From: **Monks Orchard Residents' Association Planning**

28<sup>th</sup> January 2021

Please accept this letter as a formal objection to Application **Ref: 21/00108/FUL** for Demolition of the existing dwelling and the erection of a 4-storey building comprising **9 flats** with associated landscaping and amenity space, and the relocation of a vehicular crossover at **81 The Glade** Croydon, CR0 7QN.

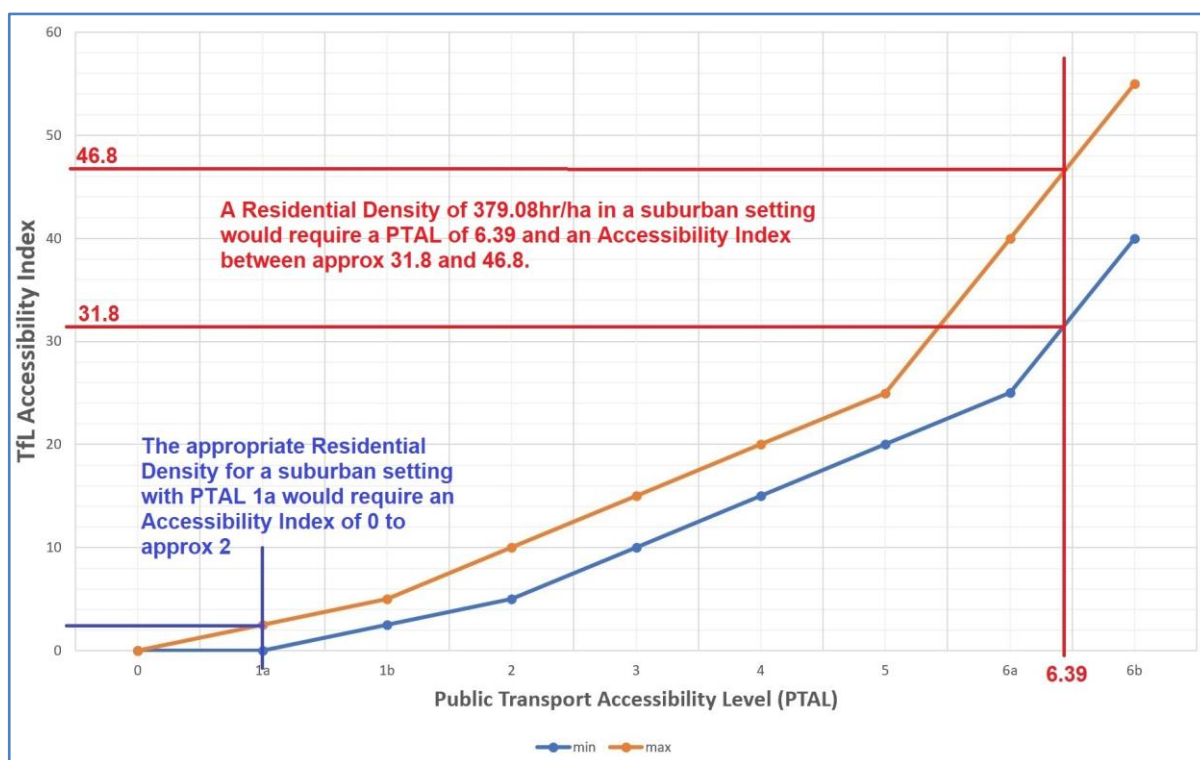
In the absence of Policies and methodologies to define appropriate Densities for Development Proposals in a Suburban Setting at low PTAL's, the above assessment is offered for consideration.

The Illustration above shows the graphical representation of The Transport for London (TfL) Accessibility Index comparisons for the proposed development at the location actually served by PTAL 1a but which would require a PTAL of 6.39 with TfL Accessibility Index required between  $\approx 31.8$  to  $\approx 46.8$  inappropriate for the area.

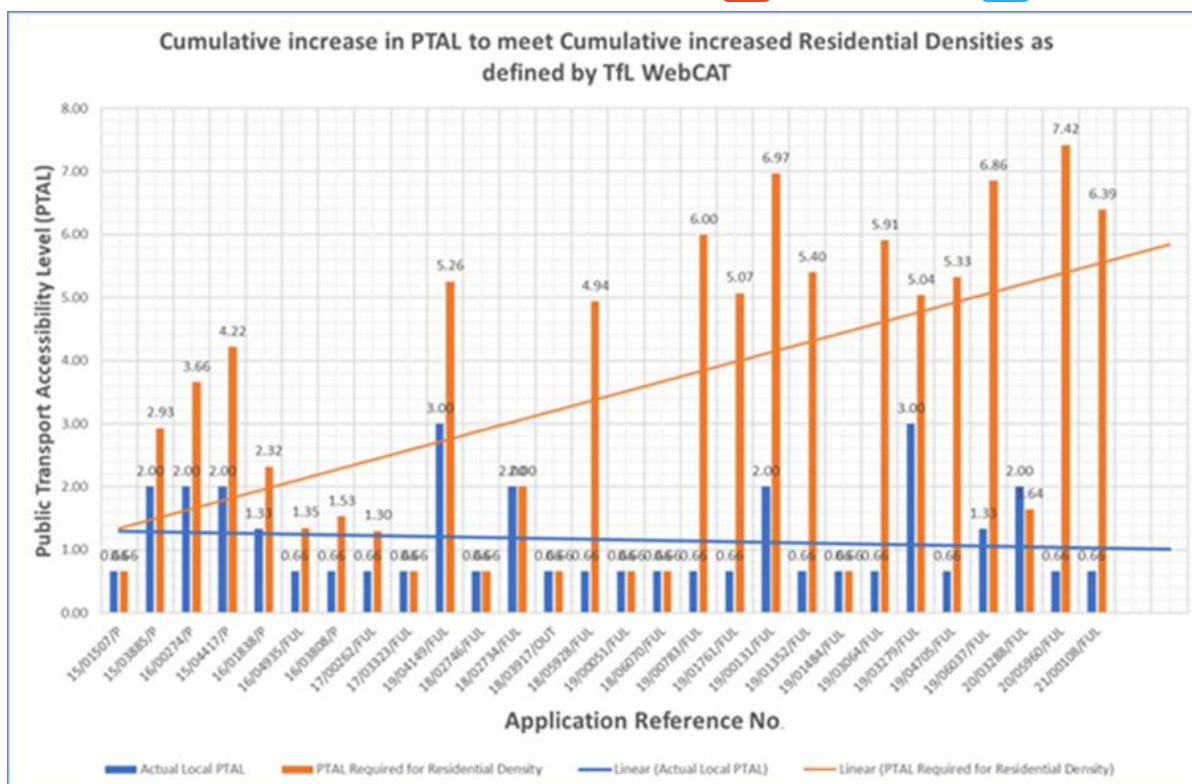
The above histogram gives an indication of Cumulative **over developments** and **unsustainable Public Transport Accessibility (PTAL)** resultant on recent '**cumulative**' piecemeal in-fill and windfall site redevelopments in the MORA Post Code Area [7] of the Shirley North Ward.
